MULTIPLE SEWERSHED PACKAGE 10B – OPEN CUT
Solicitation Number: CO-00285-SM
Job No.: 18-4542

ADDENDUM 1
08/23/19

MAP No. 164572
 SECT. No. 6
 DR. CK. JOB No. 18-4542 SHEET 6 OF 28

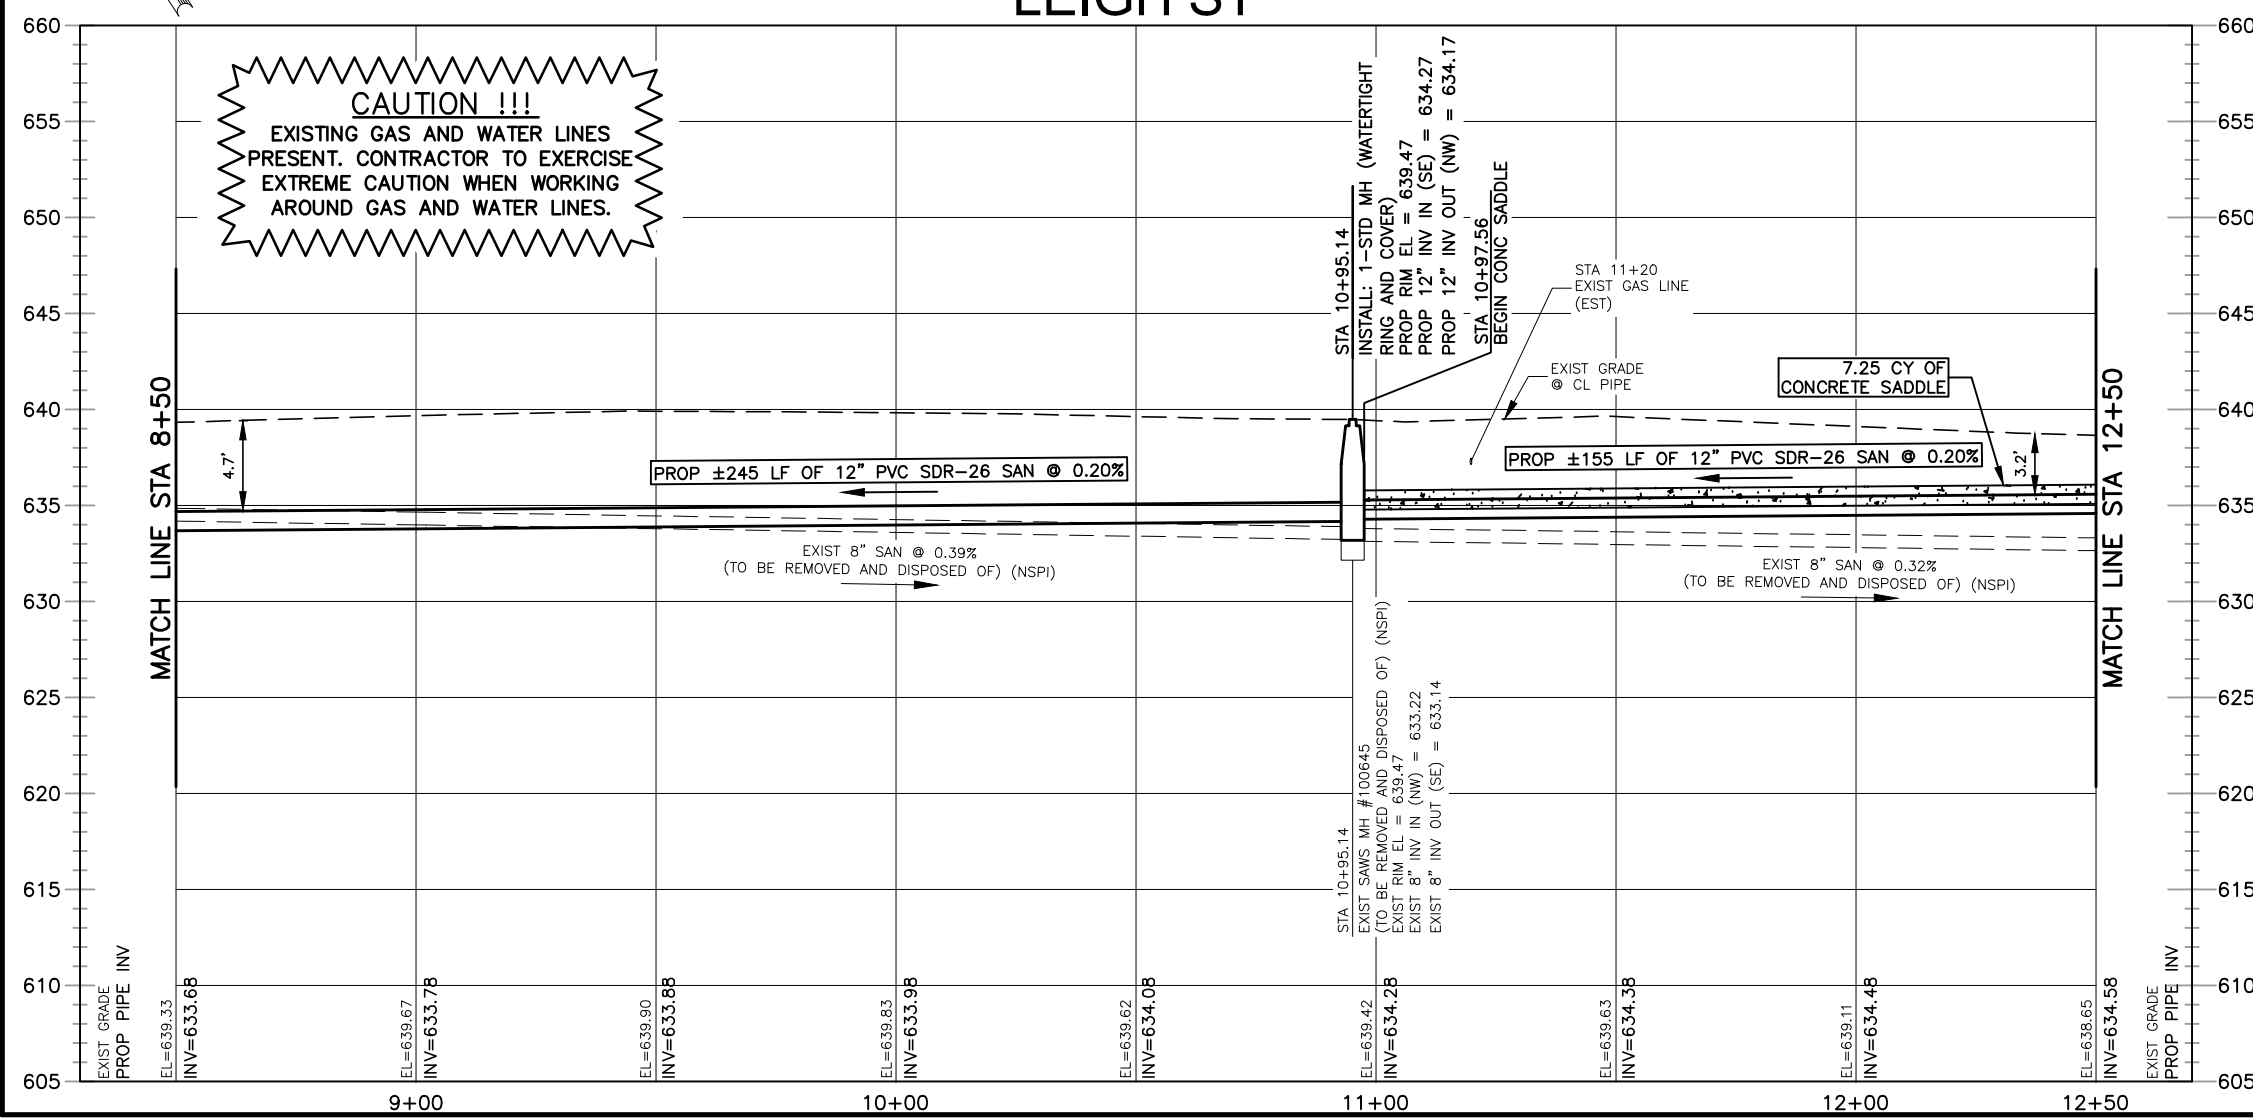
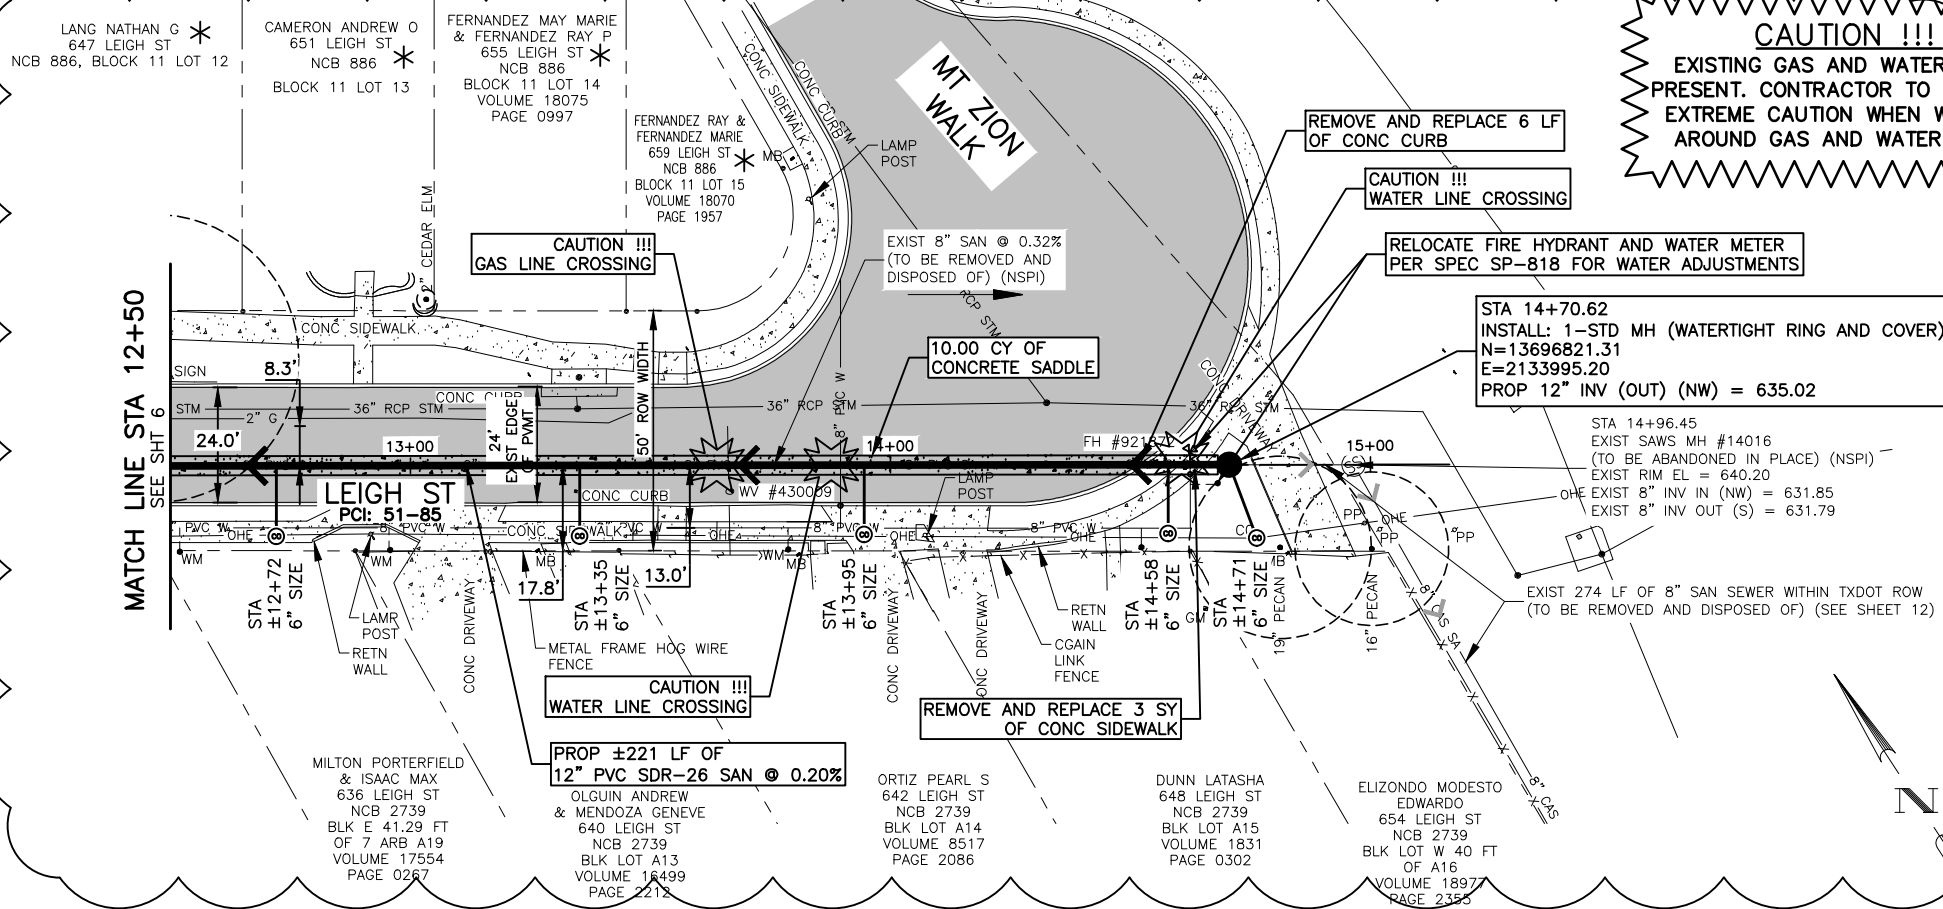
4. DELETE **Sheet 6 of 28** of the SEWER PLANS in its entirety and REPLACE with the attached **Sheet 6 of 28**, dated 8/21/19. Sheet 6 has been revised to show updated 2" gas line location.

MAP No. 164572
 SECT. No. 7
 DR. CK. JOB No. 18-4542 SHEET 7 OF 28

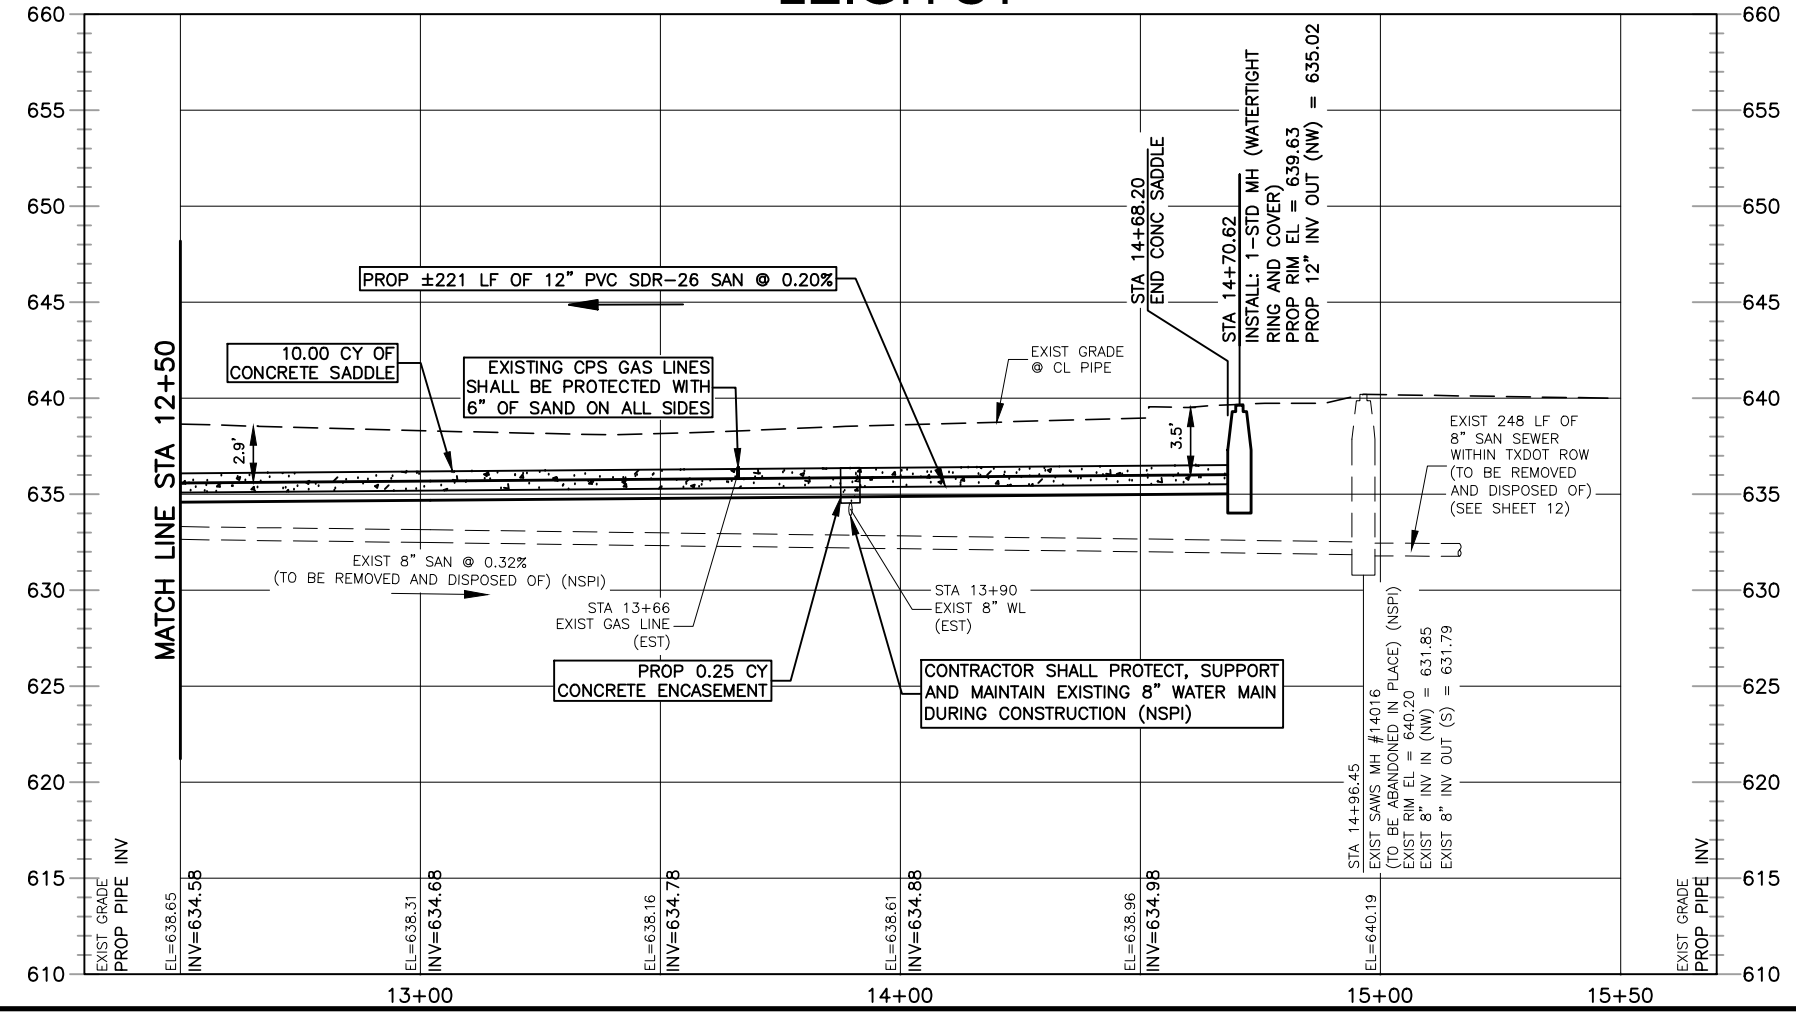
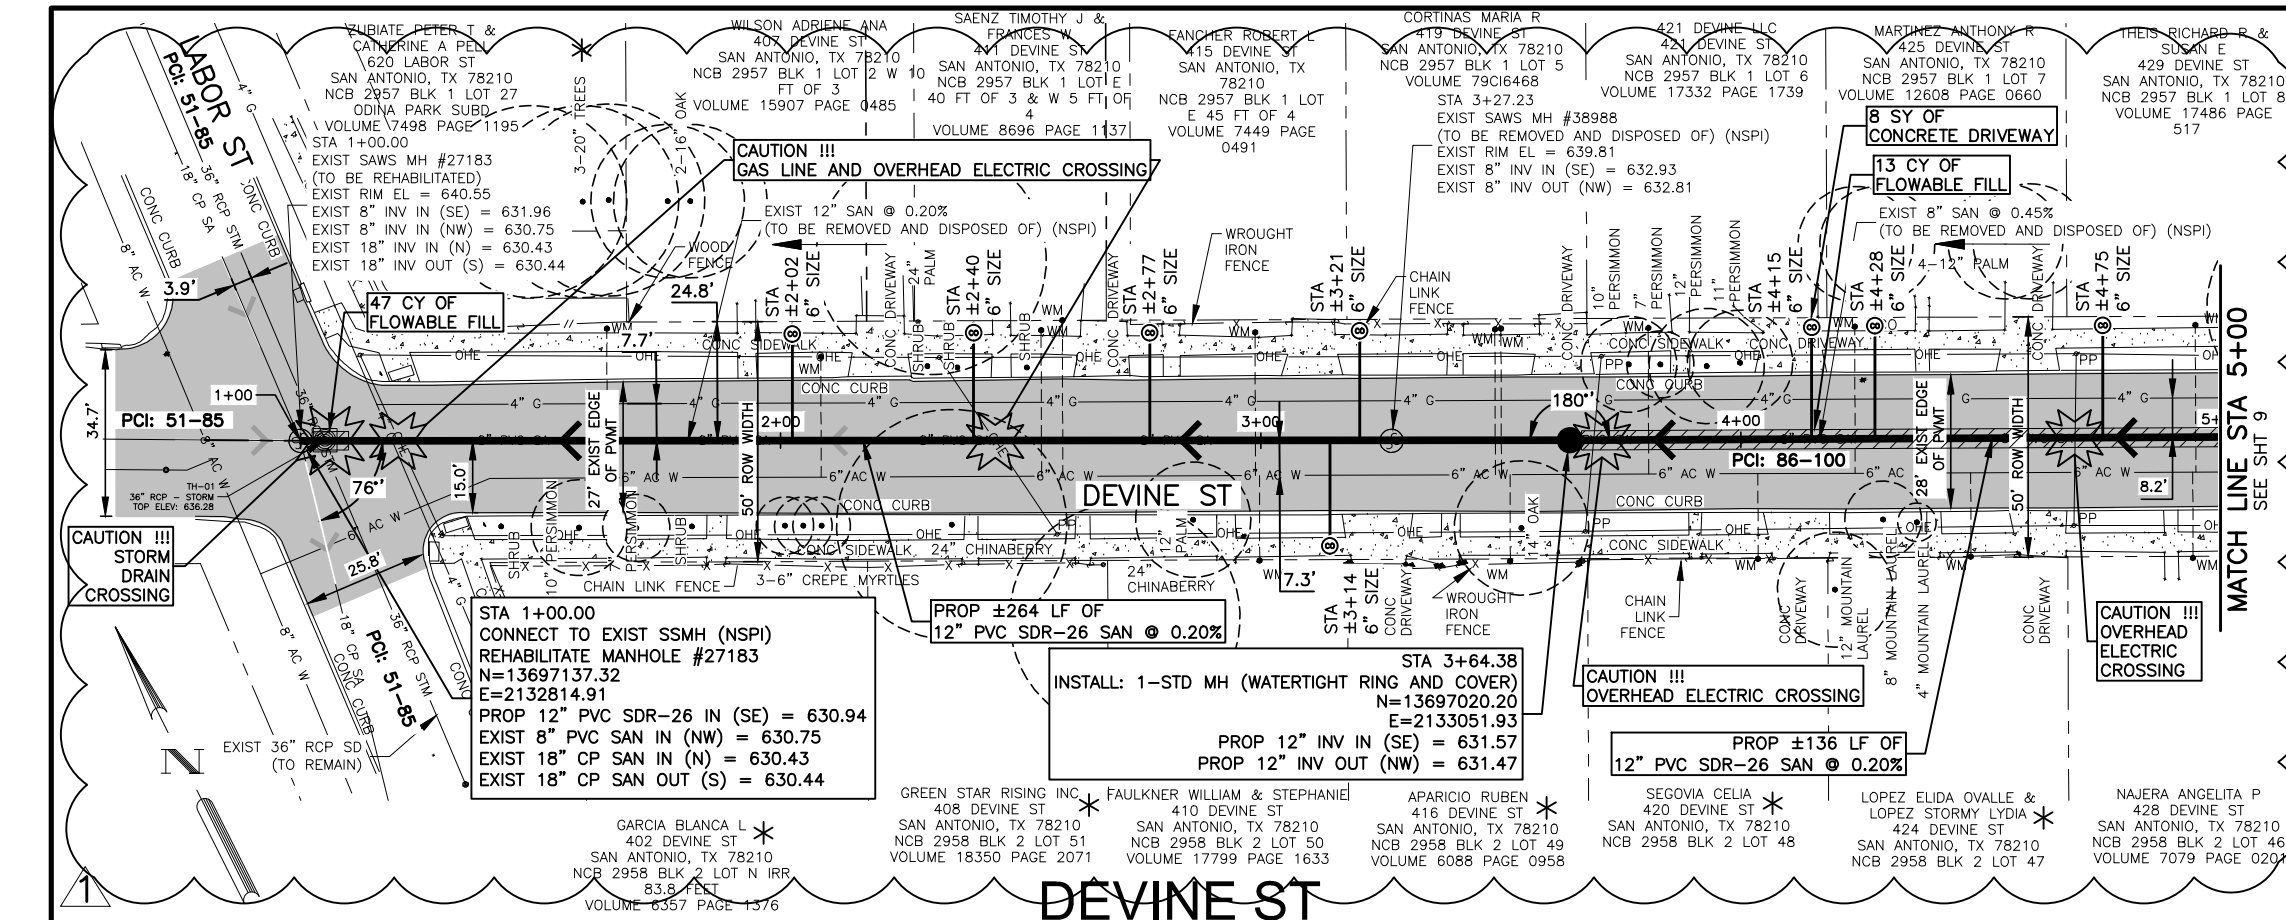
5. DELETE **Sheet 7 of 28** of the SEWER PLANS in its entirety and REPLACE with the attached **Sheet 7 of 28**, dated 8/21/19. Sheet 7 has been revised to show updated 2" gas line location.
